**CITY OF SAINT PAUL
HERITAGE PRESERVATION COMMISSION STAFF REPORT**

FILE NAME: 214 Fourth Street East
DATE OF APPLICATION: March 7, 2013
APPLICANT: Ramsey County Regional Rail Authority
OWNER: Ramsey County Regional Rail Authority
DATE OF REVIEW: March 28, 2013
HPC SITE/DISTRICT: Union Depot/Lowertown Historic District
CATEGORY: Pivotal
CLASSIFICATION: Building Permit
STAFF INVESTIGATION AND REPORT: Bill Dermody REV. by Amy Spong
DATE: March 22, 2013 Revised March 27, 2013

St. Paul Union Depot.
Carriageway.
date. 02.26.2013

Leftside...ending at VENT

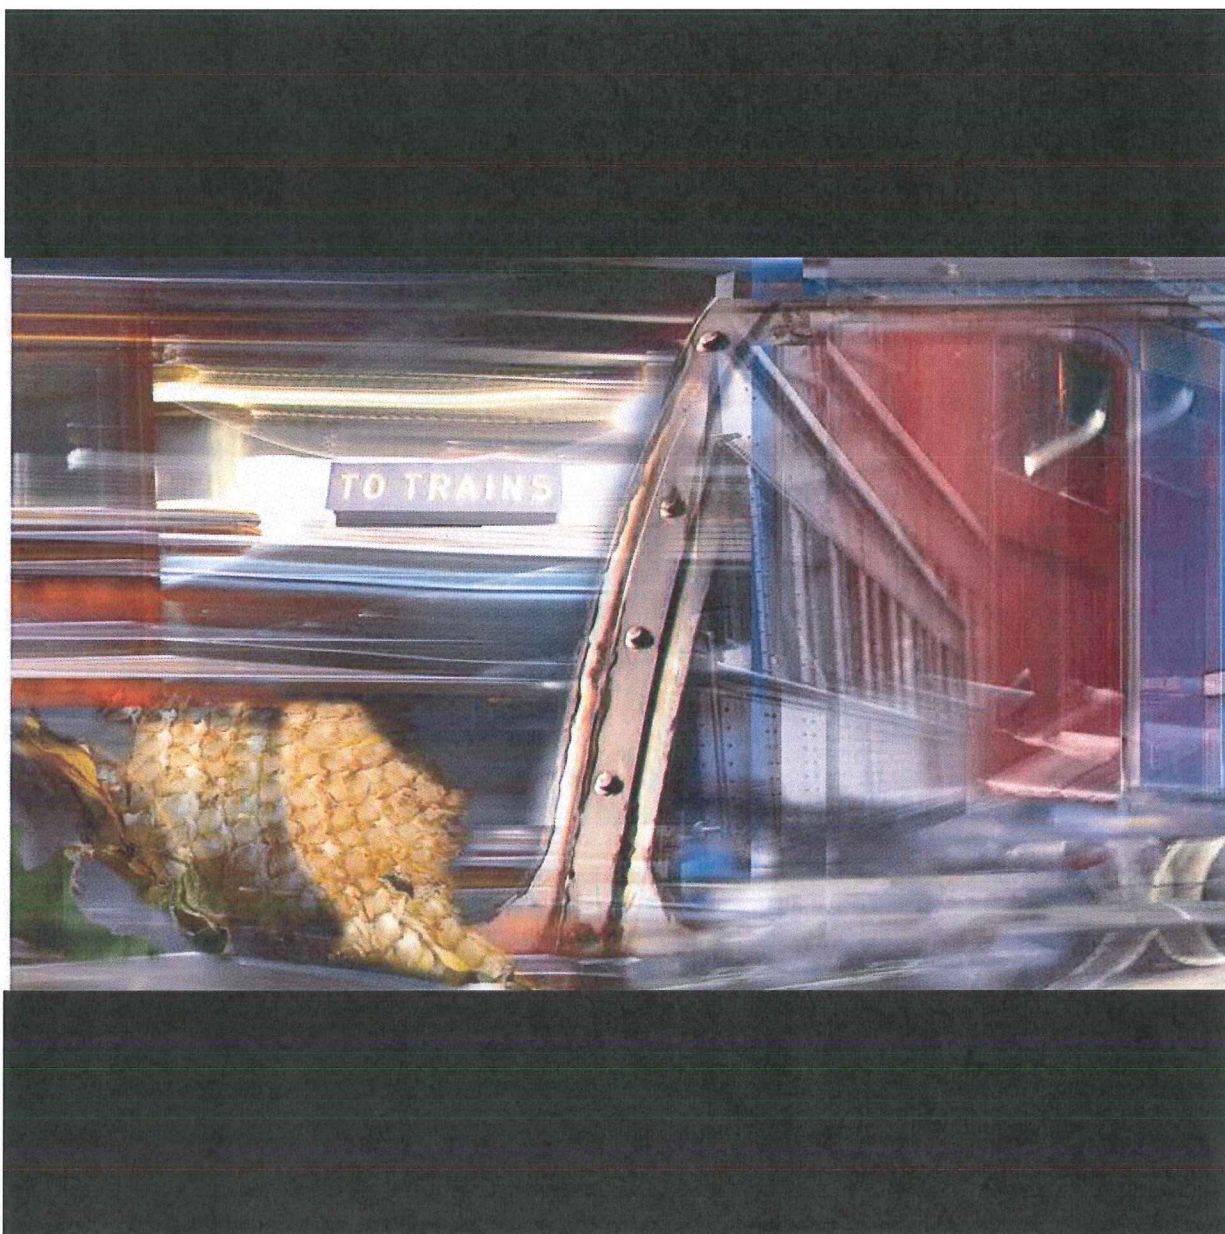
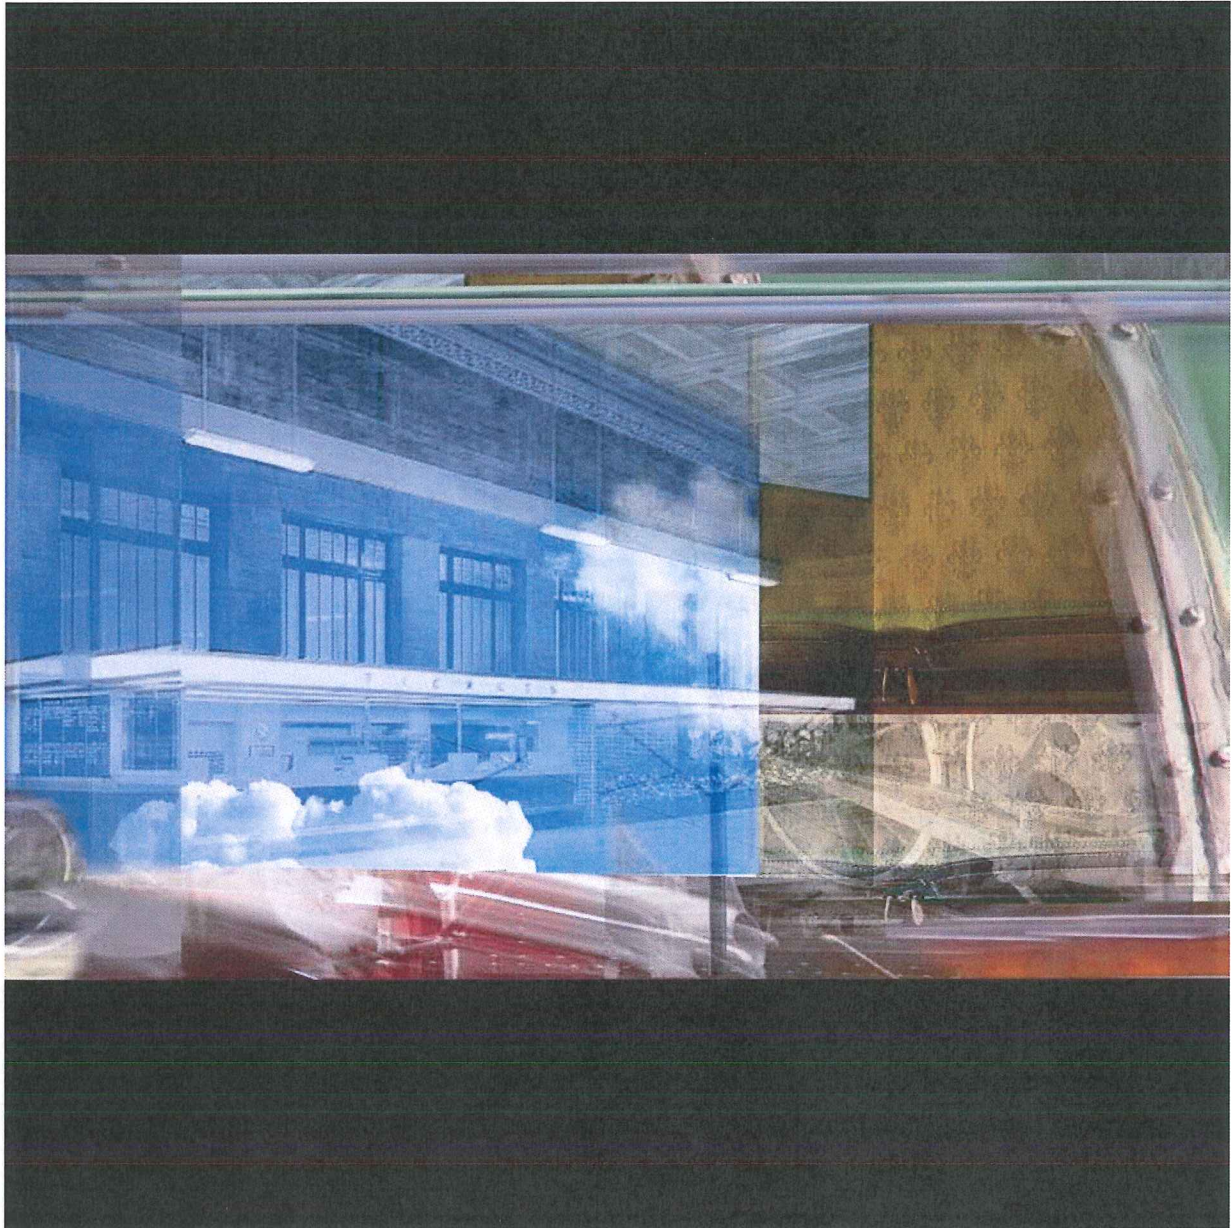
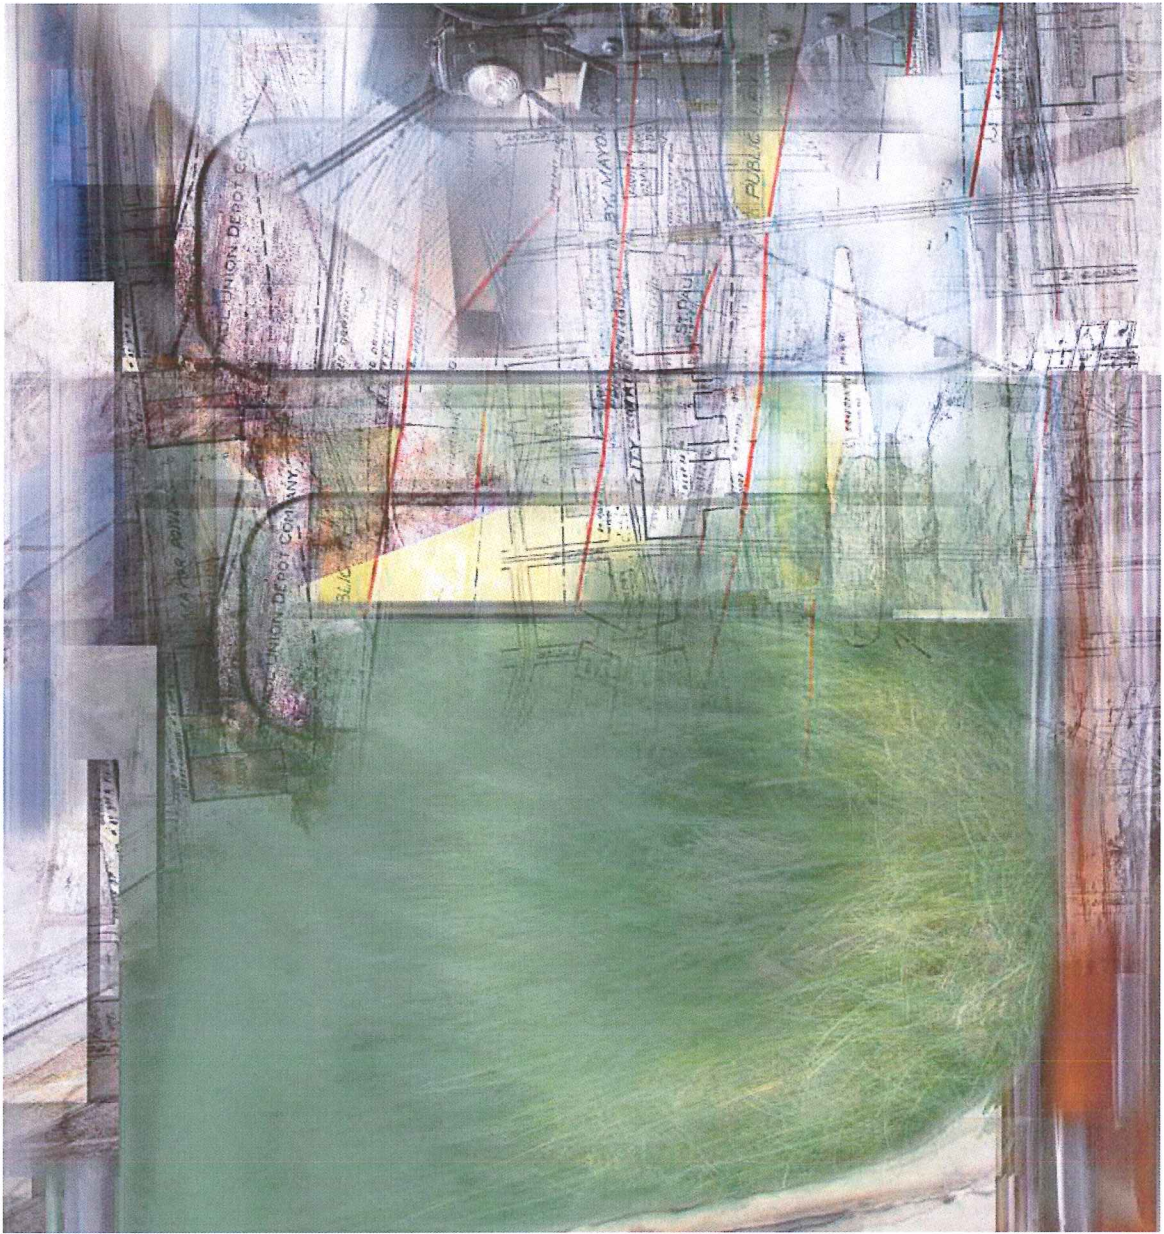
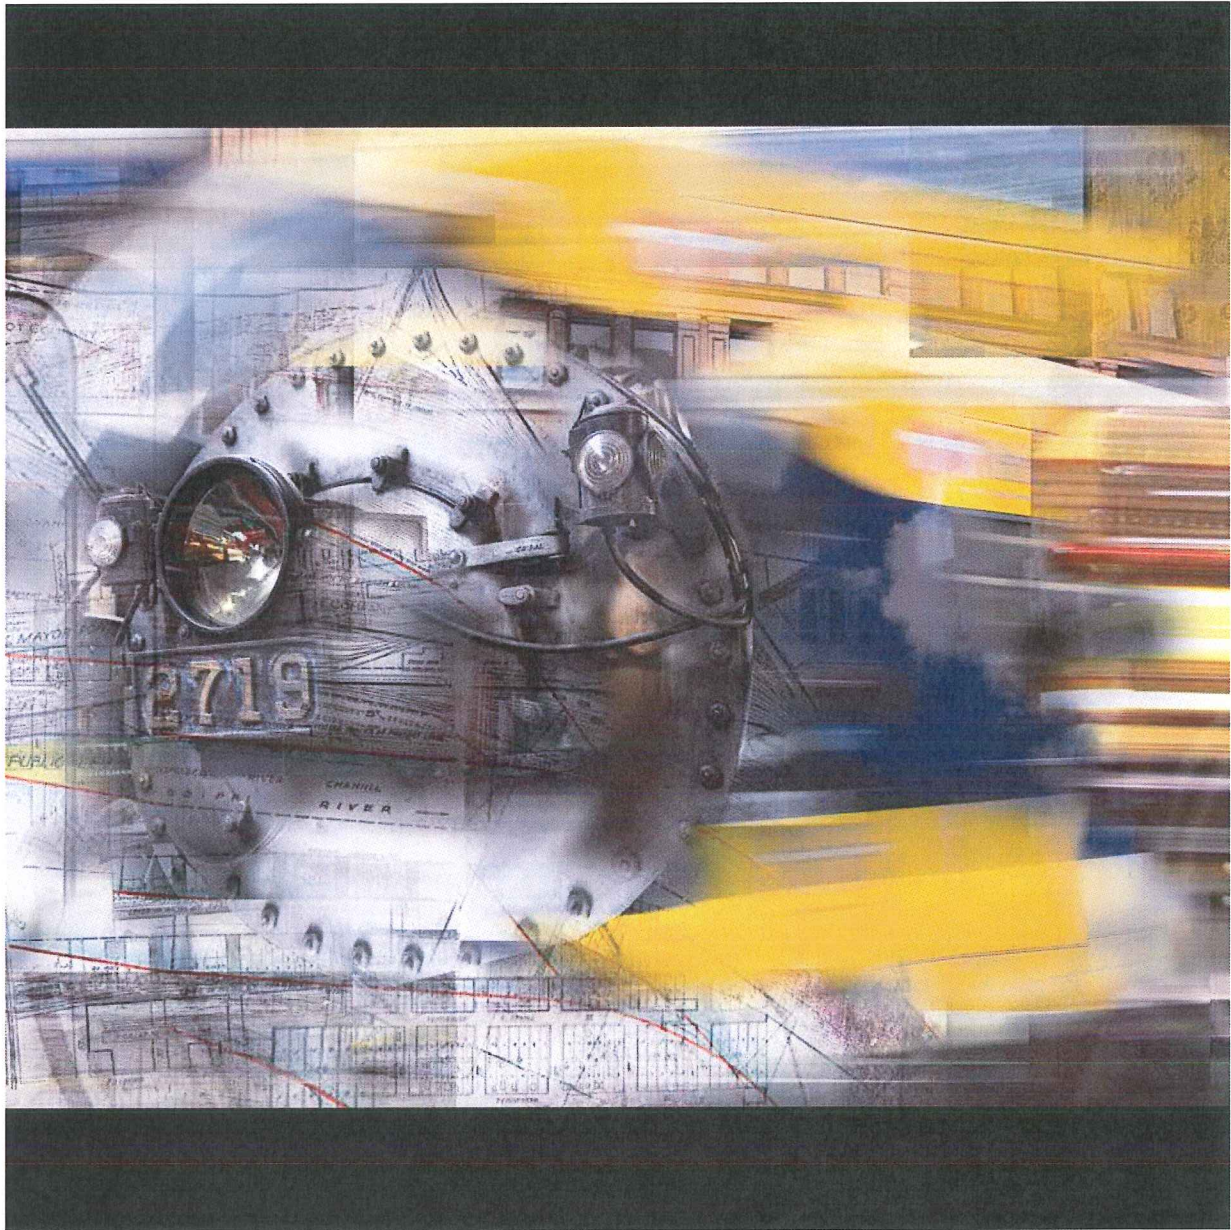
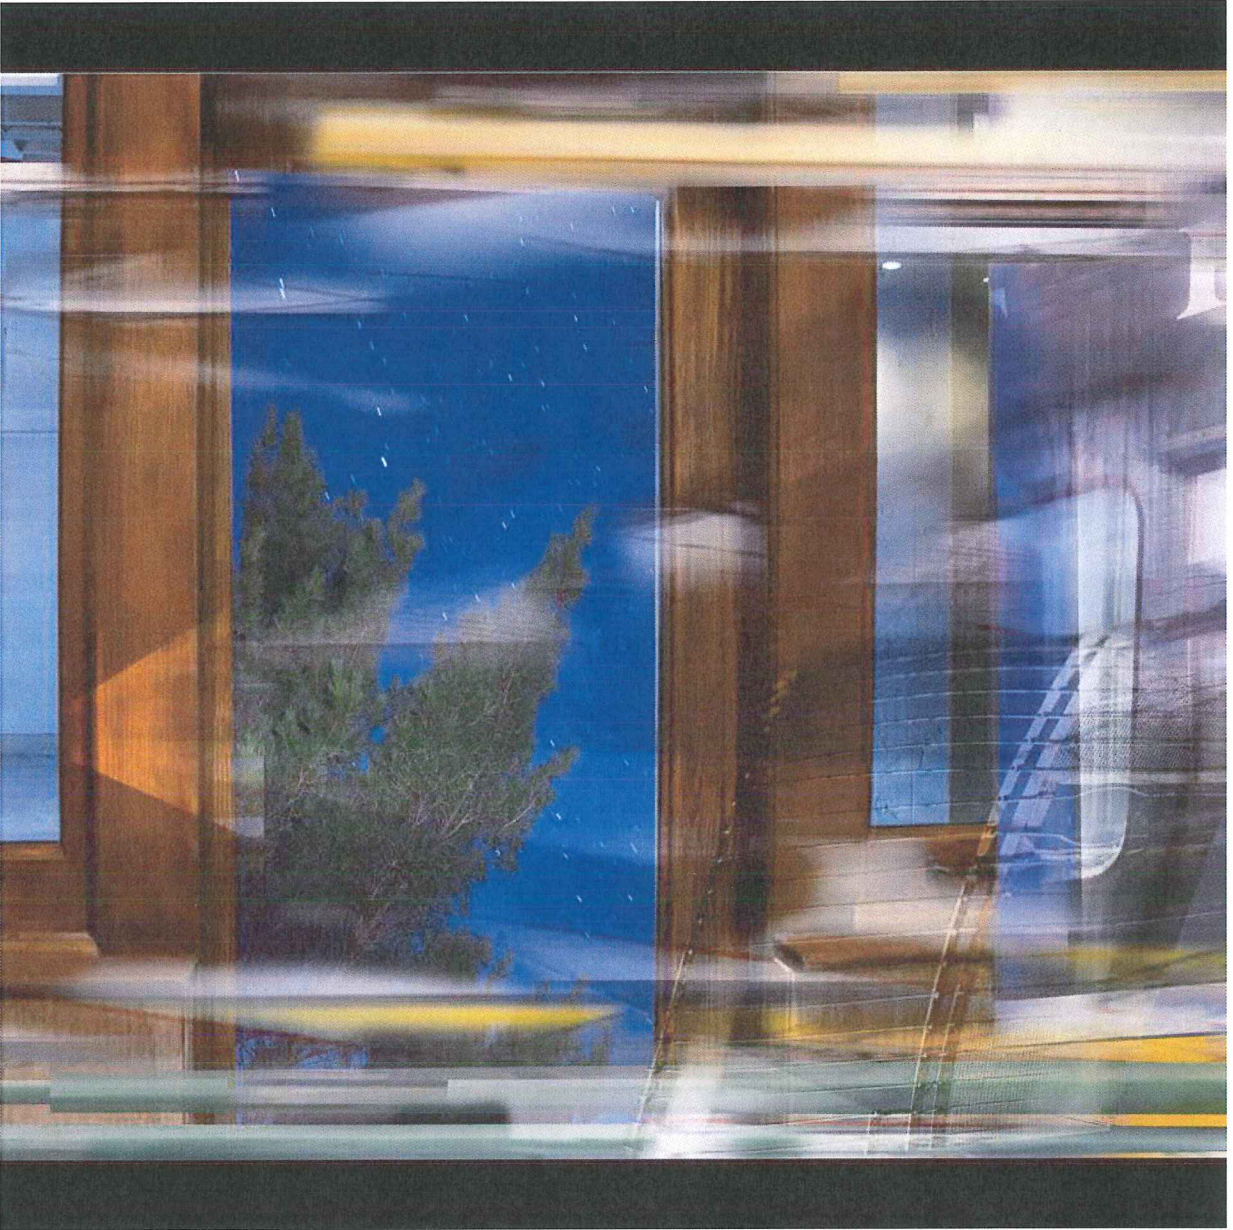
The mural contains historic and existing images from the site, the surrounding area of Lowertown, and elsewhere (Downtown, University Avenue, West Side). Also, several images relate to trains, including a historic locomotive, train wheels and windows, and signage. The Lowertown and Downtown images portray current buildings that might have been viewed historically by passengers debarking at Union Depot. The University Avenue images include buildings that might be seen by passengers on the new Green Line light rail transit service that begins operation in 2014.

The images relating to trains, the Union Depot site, and Lowertown are appropriate because they foster an understanding of the site's historic context as a pivotal building within the Lowertown Historic District. However, images from elsewhere (Downtown, University Avenue, West Side) are not necessarily consistent with the historic context at this location.

4. *Materials.* The glass-laminated tile is not an existing building material. The proposed material is appropriate at this location given much of this area is new construction and the historic character of the original carriageway is not present on the south side of the carriageway.

5. *Method of Attachment.* Attachment methods were not included in the application and should be submitted for review. There is no historic fabric that would be damaged through installation and the mural will not *disfigure or conceal architectural details*.

6. *Lighting.* Additional lighting is proposed but a specific proposal was not submitted. Guidelines state, "*Location of exterior lights should be appropriate to the structure. There should be no flashing, blinking, moving, or varying intensity lighting. Subdued lighting is preferred. Backlit fluorescent or exposed neon are generally inappropriate.*" The application also states the mural itself will have some reflectivity as vehicle headlights move through the space.

1. Final drawings shall be submitted to staff for final review and approval. These final details shall include, but not be limited to, method of attachment, section drawings showing panel specifics, lighting fixtures and placement, and material mockups. Staff shall review and approve final details.
